Type Coffee Vending Machine	Model 9100 - 95	N° T.I. 04 - 2019				
Serial Number See below	Subject FLIP HINGE CHANGE	ISSUED FOR (X) <table border="1"> <tr> <td>Action</td> <td></td> </tr> <tr> <td>Information</td> <td>X</td> </tr> </table>	Action		Information	X
Action						
Information	X

Modified flap hinge

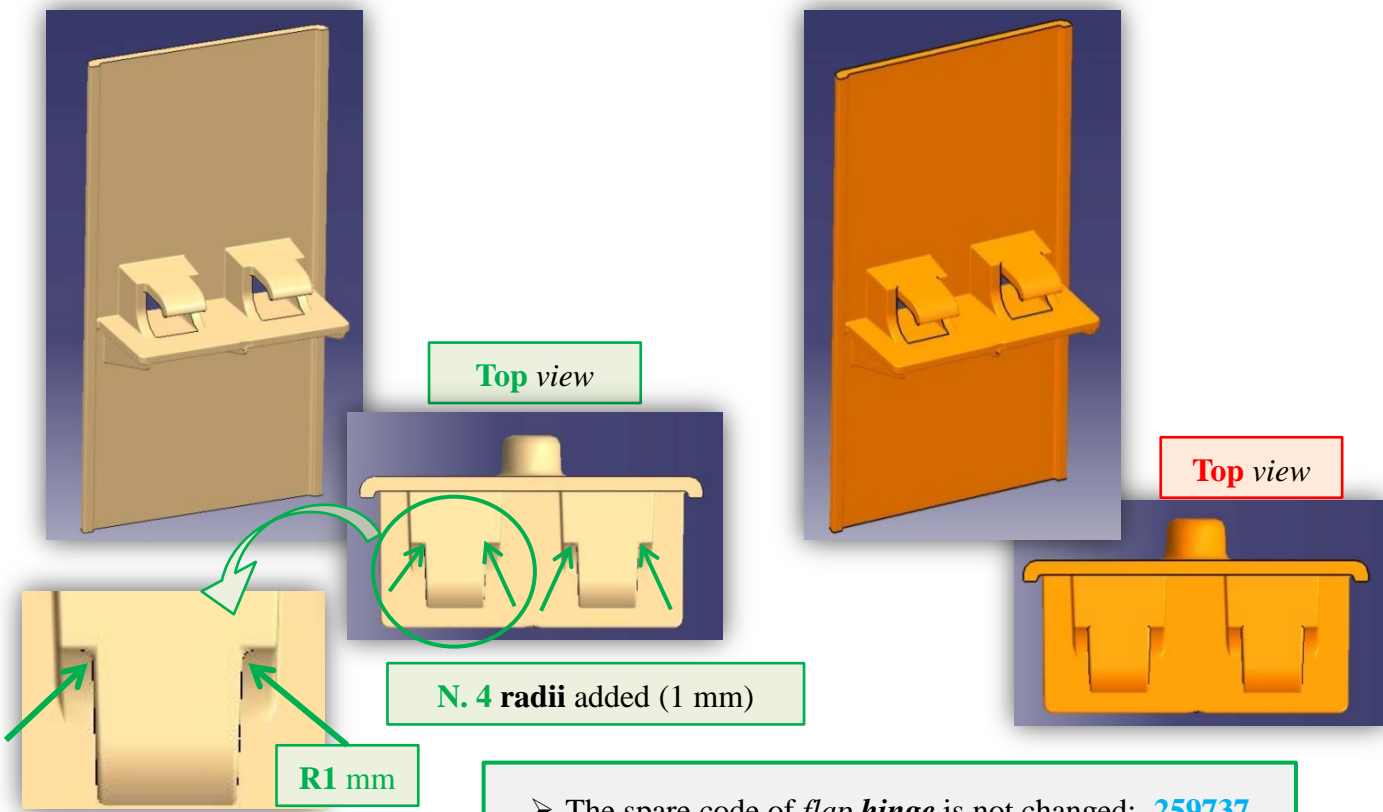
The flap **hinge** has been modified adding **N. 4 radii**, as shown below.

The modification guarantees a higher stiffness

The **modified flap hinge** can be fitted on machines previous to above **S/N**.
